IREDELL COUNTY HEALTH DEPARTMENT

IMPROVEMENT PERMIT / CERTIFICATE OF COMPLETION / OPERATION PERMIT / EXISTING SYSTEM INSPECTION

PROPERTY DESCRIPTION NO. 18332 DATE 6-29-94 TAX MAP NO. Pt. of 3Q-B-12 Watershed: ☐ Yes ☑ No

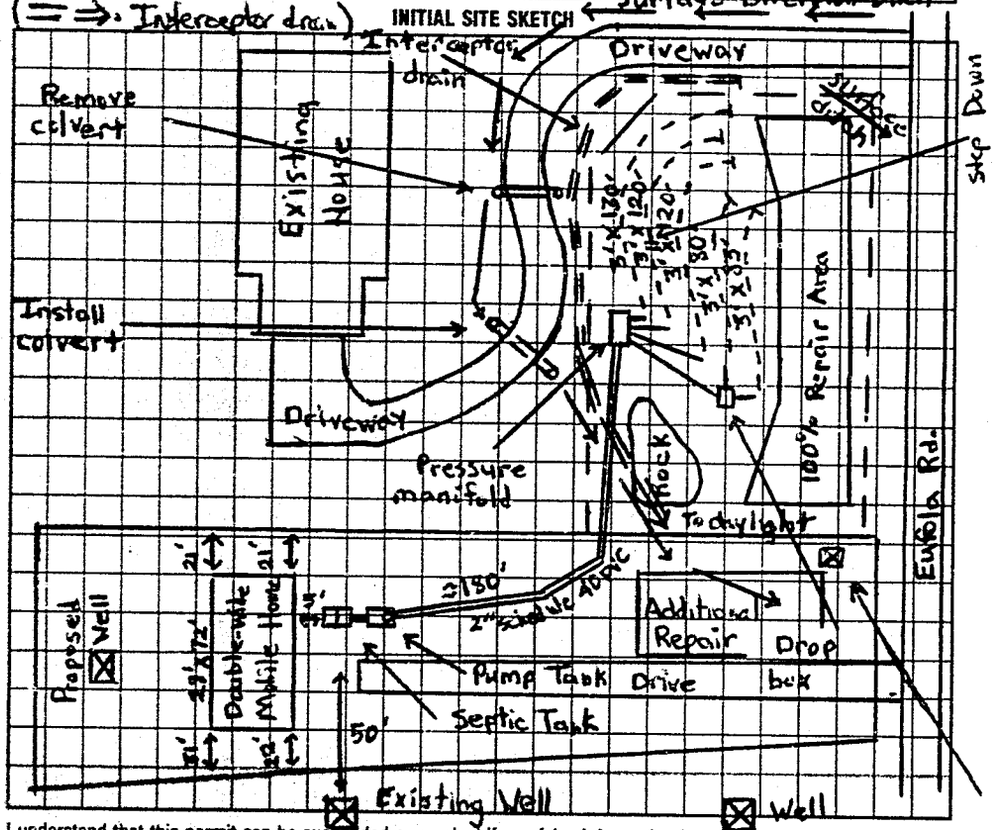
Comments: Pump to pressure manifold (see attached) INSTALL SYSTEM SHALLOW (no deeper than 24" to trench bottom) Install Lines and Trenches on contour. System to be installed in easement area. Keep system 5' from foundation of home

Comments: Cut surface diversion ditch around system, remove existing culvert, place culvert further down in driveway to allow drainage around system. Install pump that will deliver 50 GPM at 26 TDH (see attached for pump and pump tank diagram)

* Install interceptor drain around system. Min 4' deep, 6" wide with slotted corrugated pipe and gravel up to 6" of surface ≈180' in length. run to daylight.

CALL FOR INSPECTION before installing gravel in Interceptor drain.

Keep interceptor drain 10' from any part of drainfield.

AS-BUILT SKETCH

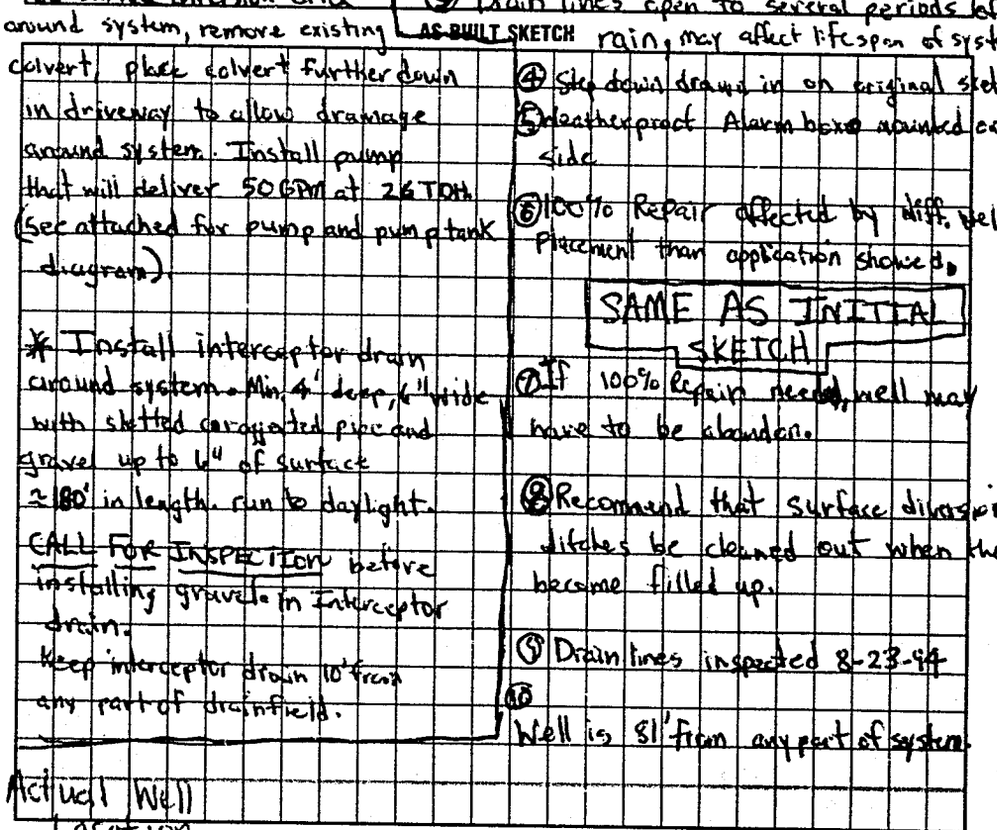
Comments: ① Inspected tanks on 8-11-94 ② Drainline #2 originally had 7" of rise, it was redone and had 6" of fall, had to install step down 30' from start of line. ③ Drain lines open to several periods of rain, may affect lifespan of system. ④ Step down drawn in on original sketch. ⑤ Weatherproof Alarm box mounted exterior side ⑥ 100% Repair affected by diff. well placement than application showed.

⑦ If 100% Repair needed, well may have to be abandon. ⑧ Recommend that surface diversion ditches be cleaned out when they become filled up. ⑨ Drain lines inspected 8-23-94 ⑩ Well is 81' from any part of system.
